Contract #: 04-0120F4Cty: SF/ALA Rte: 80 PM: 13.2/13.9File #: 69.25B**QUALITY ASSURANCE -- NON-CONFORMANCE REPORT****Location:** Changxing Island, Shanghai, P.R. China**Report No:** NCR-000594**Prime Contractor:** American Bridge/Fluor Enterprises, a JV**Date:** 04-Jan-2010**Submitting Contractor:** Zhenhua Port Machinery Company, Ltd (ZPMC), Changxing Island**NCR #:** ZPMC-0567**Type of problem:**

Reference Description: Missed UT Indication by QC in Crossbeam 16 Deck Plate to Side Plate Joint**Description of Non-Conformance:**

To:	AMERICAN BRIDGE/FLUOR, A JV 375 BURMA ROAD OAKLAND CA 95607	Date:	05-Jan-2010
Dear:	Mr. Charles Kanapicki	Contract No:	04-0120F4 04-SF-80-13.2 / 13.9
Attention:	Mr. Thomas Nilsson Project/Fabrication Manager	Job Name:	SAS Superstructure
Subject:	NCR No. ZPMC-0567	Document No:	05.03.06-000556

NCR-000583,594,602,603,625,626,627,628,644,651(ZPMC-0556,567,575,576,598,599,600,601,615,622)

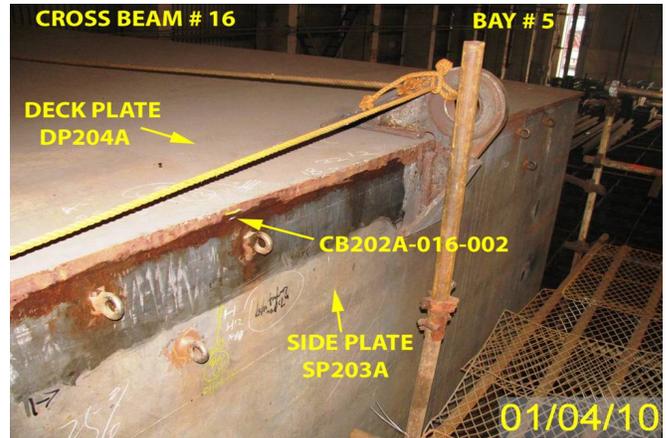
During random 10% verification Ultrasonic Testing (UT) of OBG Crossbeam 16, this Quality Assurance Inspector (QA) discovered the following issue:

One (1) Class "A" non conforming longitudinal indication measuring approximately 30 mm in length.

-The weld is a complete joint penetration (CJP) corner joint, joining Side Plate SP203A to Deck Plate DP204A and is identified as CB202A-016-002.

-The discontinuity rating is +3, Class "A" reject

-Depth of the discontinuity from face A is approximately 13 mm, and Y location was 1920mm when measured from the north end of the crossbeam.

-The Material thickness is 18 mm.

-The indication is in an area previously tested and accepted by ZPMC QC UT technicians.

Propose a resolution for the identified non-conformance with revised procedures to prevent future occurrences. Provide training required to enable the ZPMC UT technician to find these types of indications in the future. A response for the resolution of this issue is expected within 7 days.

项目名称 Project Name:	美国海湾大桥 SFOBB	部件图号 Drawing No.:	BK1	报告编号 Report No.:	B-CWR102
合同号 Contract No.:	04-0120F4	部件名称 Item Name:	DBG CANTILEVER BOX BRACKET	NDT 报告编号 NDT Report No.:	B787-MT-174
项目编号 Project No.:	ZP06-787

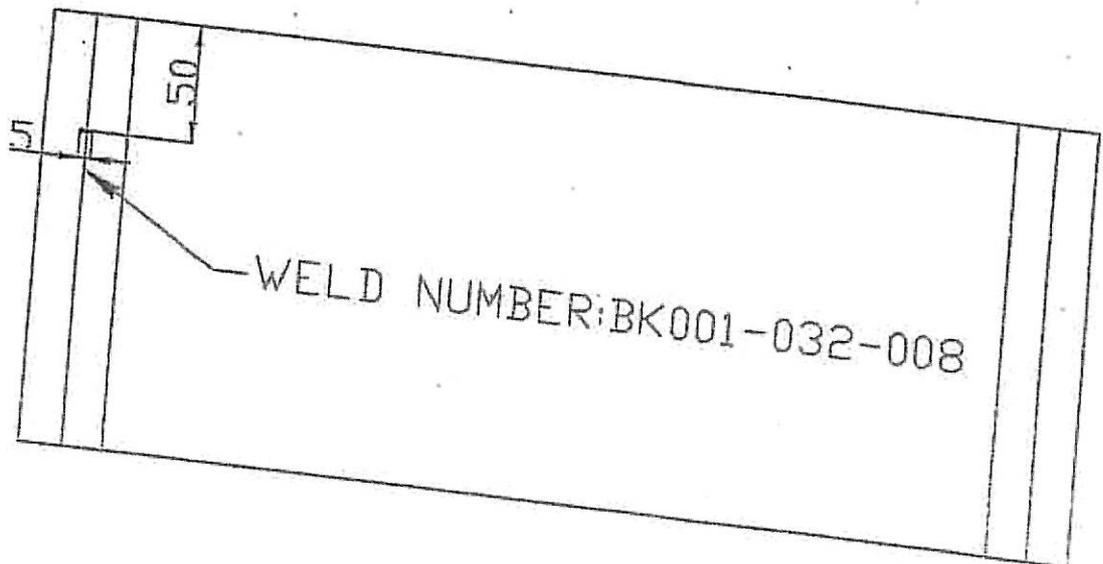
One transverse crack was found by use of MT on BK001-032-008.

2. QC and a Lead CWI shall have an approved copy of the CWR in hand prior to the repair.
3. Remove paint ≥ 25 mm in all direction of HAZ prior to MT.
4. Clean the excavation area of all loose debris including MT powder. Preheat to 65° C before removing cracks by grinding, repair area shall extend a minimum of 50mm beyond each end of single crack repairs.

6. Prepare excavation in accordance with the New Repair Procedure prior to welding.
7. Before this repair, Verify with VT and MT repair areas are defects free, and also MT shall be performed on the base metal laying abroad cracks to ensure that no cracks were propagated to the base metal. Separate CWR approval is needed if cracks are found in the base metal, and only after this new CWR's approval can continue the repair.

项目名称 Project Name	美国海湾大桥 SFOBB	部件图号 Drawing No	CB202A	报告编号 Report No.	B-WR10060
合同号 Contract No.	04-0120F4	部件名称 Items Name	CB16 STRUT	NDT报告编号 Report No. of NDT	B787-UT-10854
项目编号 Project No.:	ZP06-787

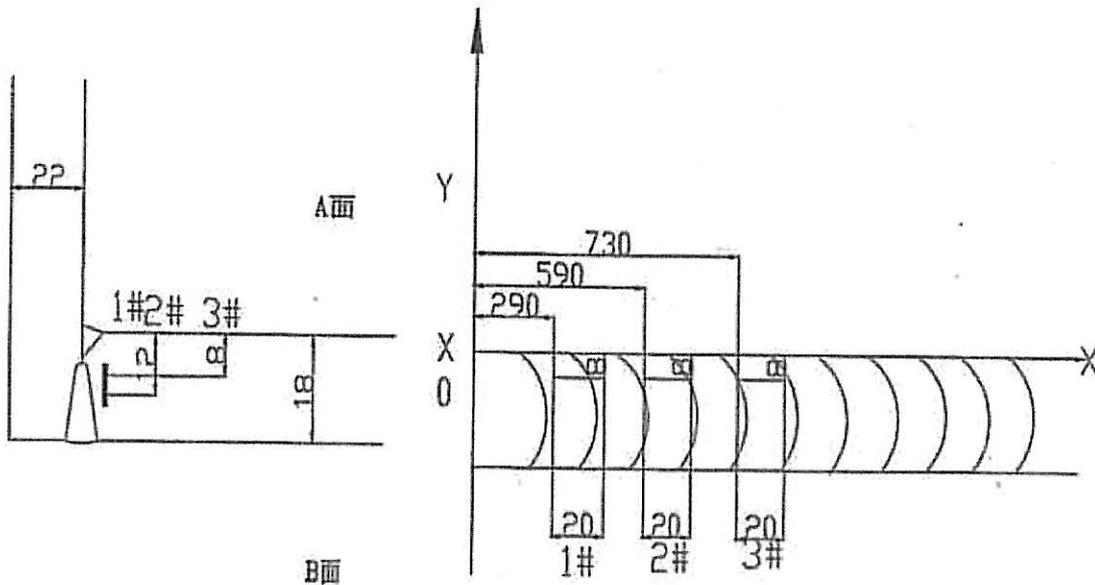
Rejected indication found by ultrasonic inspection is less than the maximum allowance aggregate length.

(UT探伤发现的缺陷总长度小于最大允许长度。) CB202A-016-002

1. 从缺陷距离端面较近一侧 ($D \leq 0.65T$, D为缺陷深度, T为板厚) 采用碳锉或打磨的方法去除焊缝缺陷;
 2. 参照返修焊接工艺规程 (WPS) 准备正确的接头型式, 预热和焊接;
 3. 焊前对修补区域进行VT检测保证缺陷完全被清除;
 4. 将修补区域打磨到与母材或邻近焊缝平齐;
 5. 根据批准的车间图纸检查焊缝.
-
1. Gouge or grind from nearer side from metal edge ($D \leq 0.65T$, "D" is depth of defects, "T" is thickness of metal) to remove all defects;
 2. Follow repair WPS for joint preparation, preheat, and weld deposit;
 3. Verify with VT no defects remain in the weld joint prior to welding;
 4. Grind the repaired area flush with base metal or the adjacent weld;
 5. Check the welds according to the working drawings;

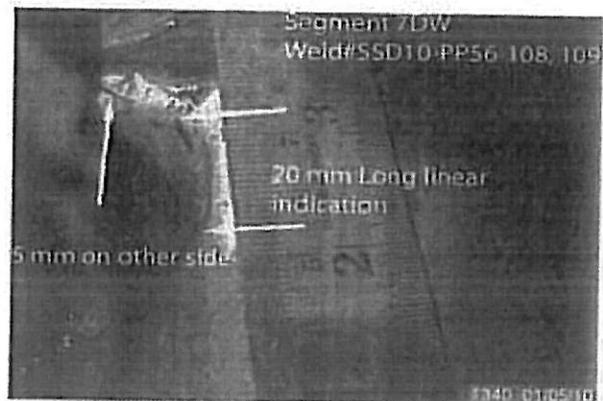
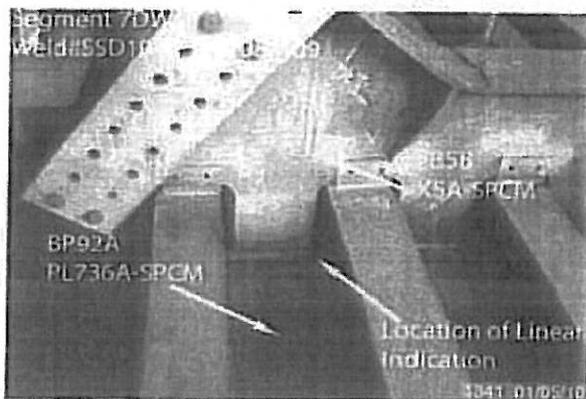
-One (1) Longitudinal linear indication measuring approximately 20mm in length.

-The welds are identified as: SSD10-PP56-108, 109.

-These welds are a Fillet Weld type joining the Bottom Plate (BP92A) to Floor Beam (FB5B) web plate.

-These welds are designated as Seismic Performance Critical Member (SPCM) on the approved drawing (SEGSD10).

项目名称 Project Name:	美国海湾大桥 SFOBB	部件图号 Drawing No.:	SSD10	报告编号 Report No.:	B-CWR1043
合同号 Contract No.:	04-0120F4	部件名称 Item Name:	OBG FLOOR BEAM AND BOTTOM PLAT E	NDT 报告编号 NDT Report No.:	B787-MT-17605
项目编号 Project No.:	ZP06-787

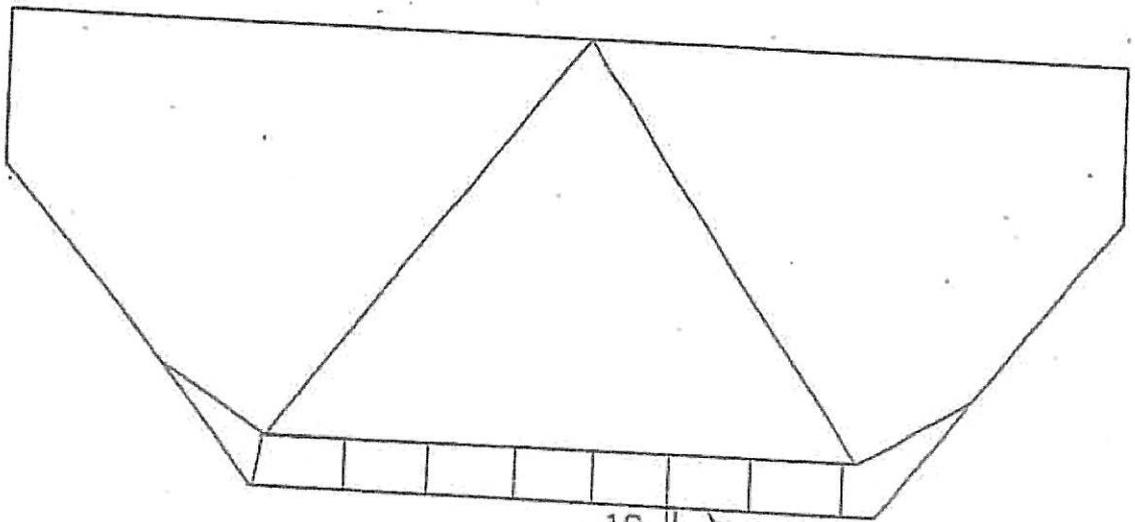
One longitudinal crack was found by use of MT on SSD10-PP56-108.

2. QC and a Lead CWI shall have an approved copy of the CWR in hand prior to the repair.
3. Remove paint $\geq 25\text{mm}$ in all direction of HAZ prior to MT.

6. Prepare excavation in accordance with the New Repair Procedure prior to welding.
7. Before this repair, Verify with VT and MT repair areas are defects free, and also MT shall be performed on the base metal laying abroad cracks to ensure that no cracks were propagated to the base metal. Separate CWR approval is needed if cracks are found in the base metal, and only after this new CWR's approval can continue the repair.

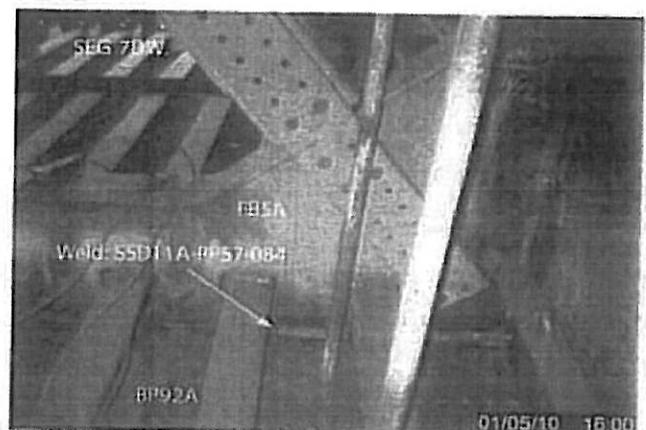
One (1) longitudinal linear indication measuring approximately 10 mm in length.

-The member is identified as FL2-2 Floor Beam FB005-025

-The weld is a fillet weld T-joint, joining FB005-025 to Seismic Performance Critical Material (SPCM) bottom panel identified as BP092A.

-The weld is identified as SSD11A-PP57-084.

-The approved shop drawings, detail this weld as a Fracture Critical Weld (FCW).

项目名称 Project Name:	美国海湾大桥 SFOBB	部件图号 Drawing No.:	SSD11	报告编号 Report No.:	B-CWR1044
合同号 Contract No.:	04-0120F4	部件名称 Item Name:	OBG FLOOR BEAM AND BOTTOM PLAT E 7DW	NDT 报告编号 NDT Report No.:	B787-MT-1760
项目编号 Project No.:	ZP06-7B7

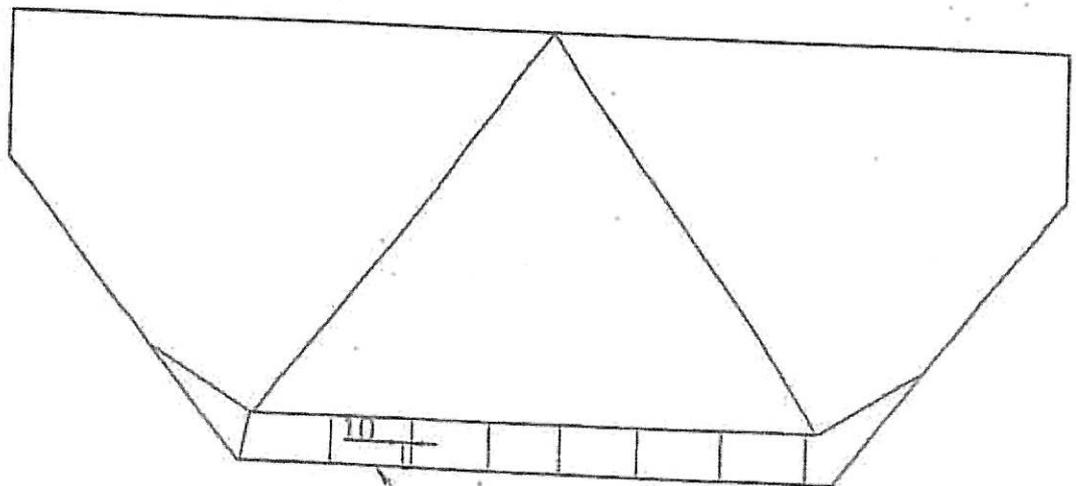
One longitudinal crack was found by use of MT on SSD11-PP57-0B4.

2. QC and a Lead CWI shall have an approved copy of the CWR in hand prior to the repair.
3. Remove paint ≥ 25 mm in all direction of HAZ prior to MT.
4. Clean the excavation area of all loose debris including MT powder. Preheat to 65° C before removing cracks by grinding, repair area shall extend a minimum of 50mm beyond each end of single crack repairs.

6. Prepare excavation in accordance with the New Repair Procedure prior to welding.
7. Before this repair, Verify with VT and MT repair areas are defects free, and also MT shall be performed on the base metal laying abroad cracks to ensure that no cracks were propagated to the base metal. Separate CWR approval is needed if cracks are found in the base metal, and only after this new CWR's approval can continue the repair.

项目名称 Project Name:	美国梅湾大桥 SFOBB	部件图号 Drawing No.:	SSD11	报告编号 Report No.:	B-CWR1
合同号 Contract No.:	04-0120F4	部件名称 Item Name:	BCW FLOOR BEAM SPLICE	NDT 报告编号 NDT Report No.:	B787-MT-1
项目编号 Project No.:	ZP06-787

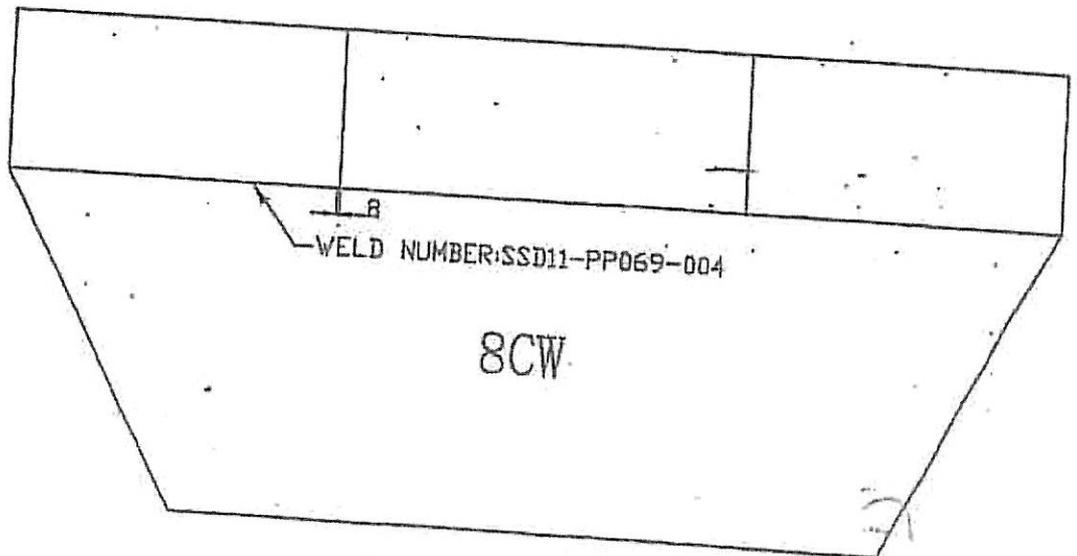
One longitudinal crack was found by use of MT on SSD11-PP69-004.

2. QC and a Lead CWI shall have an approved copy of the CWR in hand prior to the repair.
3. Remove paint ≥ 25 mm in all direction of HAZ prior to MT.
4. Clean the excavation area of all loose debris including MT powder. Preheat to 85° C before removing cracks by grinding, repair area shall extend a minimum of 50mm beyond each end of single crack repairs.

6. Prepare excavation in accordance with the New Repair Procedure prior to welding.
7. Before this repair, Verify with VT and MT repair areas are defects free, and also MT shall be performed on the base metal laying abroad cracks to ensure that no cracks were propagated to the base metal. Separate CWR approval is needed if cracks are found in the base metal, and only after this new CWR's approval can continue the repair.

Reference Description: MT Transverse Crack discovered after ZPMC tested and accepted this weld (7DW floorbeam to deck panel diaphragm joint)

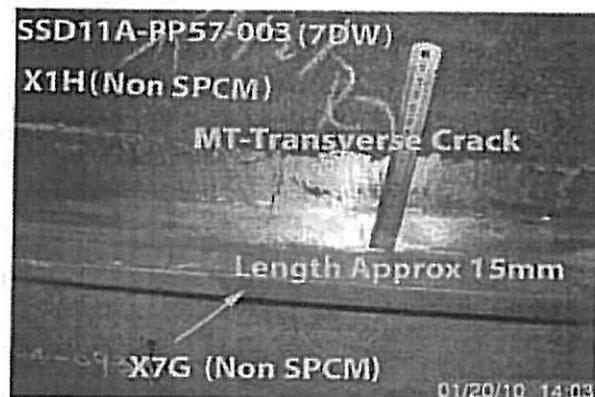
Joint fit-up Coating Other Component: 7DW Floor Beam to Deck Panel Diaphragm

Procedural Procedural Description: Missed MT transverse indication by QC

项目名称 Project Name:	美国海湾大桥 SFOBB	部件图号 Drawing No.:	SEG039	报告编号 Report No.:	B-CWR1167
合同号 Contract No.:	04-0120F4	部件名称 Item Name:	DBG DECK PLATE SPlice 7BW	NDT 报告编号 NDT Report No.:	B787-MT-18475
项目编号 Project No.:	ZP06-787

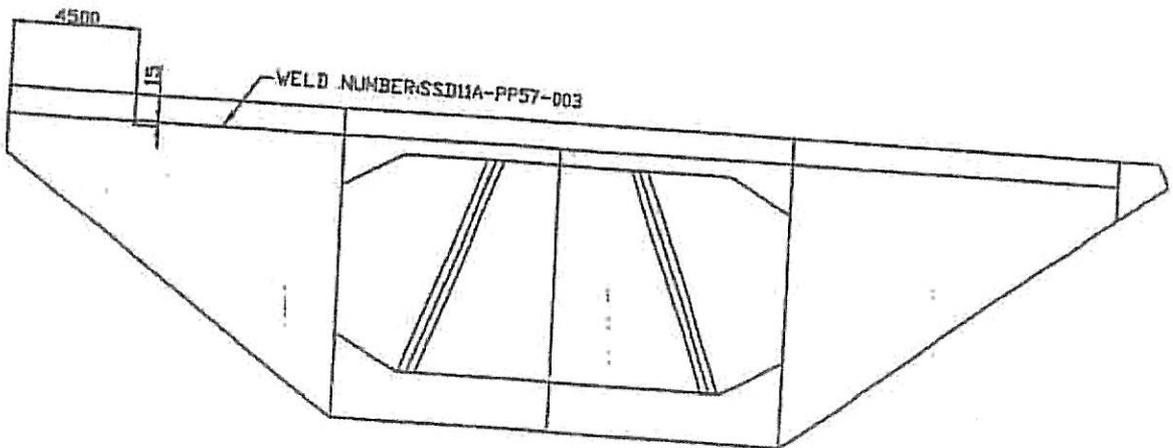
One transverse crack was found by use of MT on SSD11A-PP57-003.

14. 返修后根据图纸进行VT, UT和MT检测, 并按照合同10-1.59 "钢结构" 中的 "检测和试验" 要求进行附加MT检测.
1. QC and a Lead CWI shall be present, direct and supervise all grinding and welding operations during this repair to ensure the repair is per the disposition requirements.

2. QC and a Lead CWI shall have an approved copy of the CWR in hand prior to the repair.
 3. Remove paint ≥ 25 mm in all direction of HAZ prior to MT.
 4. Clean the excavation area of all loose debris including MT powder. Preheat to 65° C before removing cracks by grinding and it applied to all the repair process. Repair area shall extend a minimum of 50mm beyond each end of single crack repairs,

7. Before this repair, Verify with VT and MT repair areas are defects free, and also MT shall be performed on the base metal laying around cracks to ensure that no cracks were propagated to the base metal. Separate CWI approval is needed if cracks are found in the base metal, and only after this new CWR's approval can continue the repair.

Reference Description: Missed MT Indication by QC for a weld joint on the Lift 12 Longitudinal Shear Plate

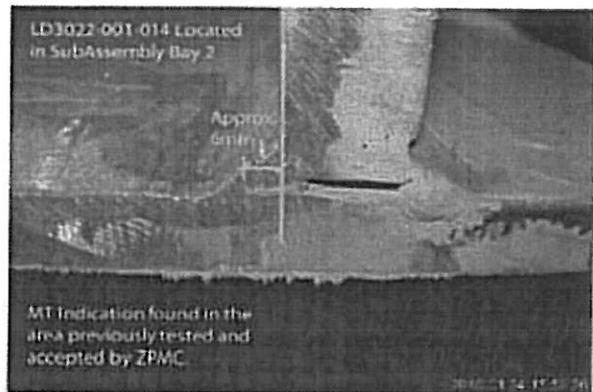
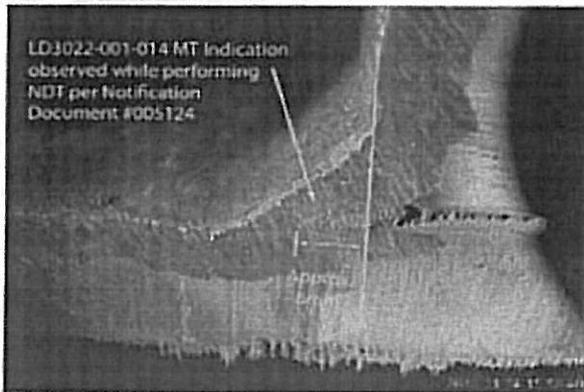
- Welding Concrete Other
- Welding Curing Procedural Bridge No: 34-0006
- Joint fit-up Coating Other Component: Lift 12 Longitudinal Shear Plate
- Procedural Procedural Description: Missed MT indication by QC

项目名称 Project Name:	美国海湾大桥 SFOBB	部件图号 Drawing No.:	LD3022	报告编号 Report No.:	B-CWR1151
合同号 Contract No.:	04-0120F4	部件名称 Item Name:	12 th lifting longitudinal diaphragm	NDT 报告编号 NDT Report No.:	B787-MT-17930
项目编号 Project No.:	ZP06-787

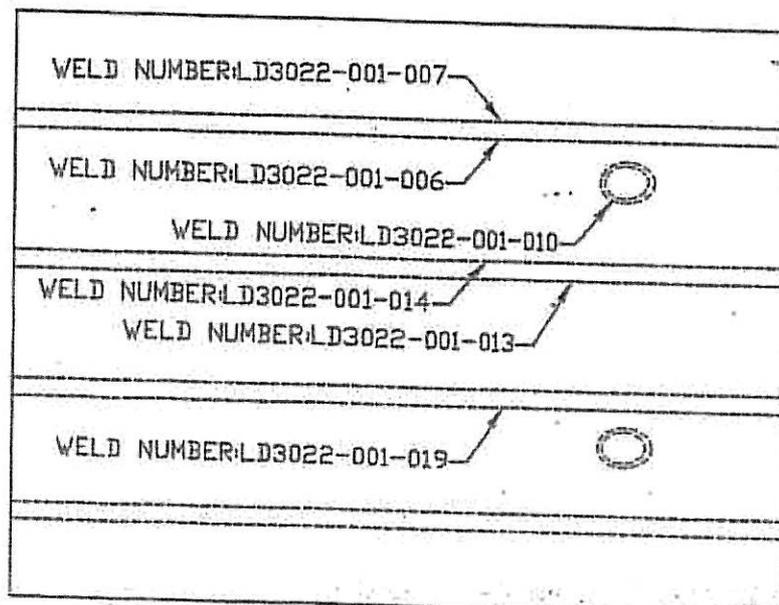
One pore and two transverse cracks were found by use of MT on LD3022-001-006.
One longitudinal crack and four transverse cracks were found by use of MT on LD3022-001-007.
One pore and one transverse crack were found by use of MT on LD3022-001-010.
One pore and two transverse cracks were found by use of MT on LD3022-001-013.
One longitudinal crack and one transverse crack were found by use of MT on LD3022-001-014.
One pore and one transverse crack were found by use of MT on LD3022-001-019.

2. QC and a Lead CWI shall have an approved copy of the CWR in hand prior to the repair.
3. Remove paint ≥ 25 mm in all direction of HAZ prior to MT.
4. Clean the excavation area of all loose debris including MT powder. Preheat to 65° C before removing cracks by grinding, repair area shall extend a minimum of 50mm beyond each end of single crack repairs, and 50mm beyond the outermost cracks for multiple crack repairs

6. Prepare excavation in accordance with the New Repair Procedure prior to welding.
7. Before this repair, Verify with VT and MT repair areas are defect free, and also MT shall be performed on the base metal laying abroad cracks to ensure that no cracks were propagated to the base metal. Separate CWR approval is needed if cracks are found in the base metal, and only after this new CWR's approval can continue the repair.
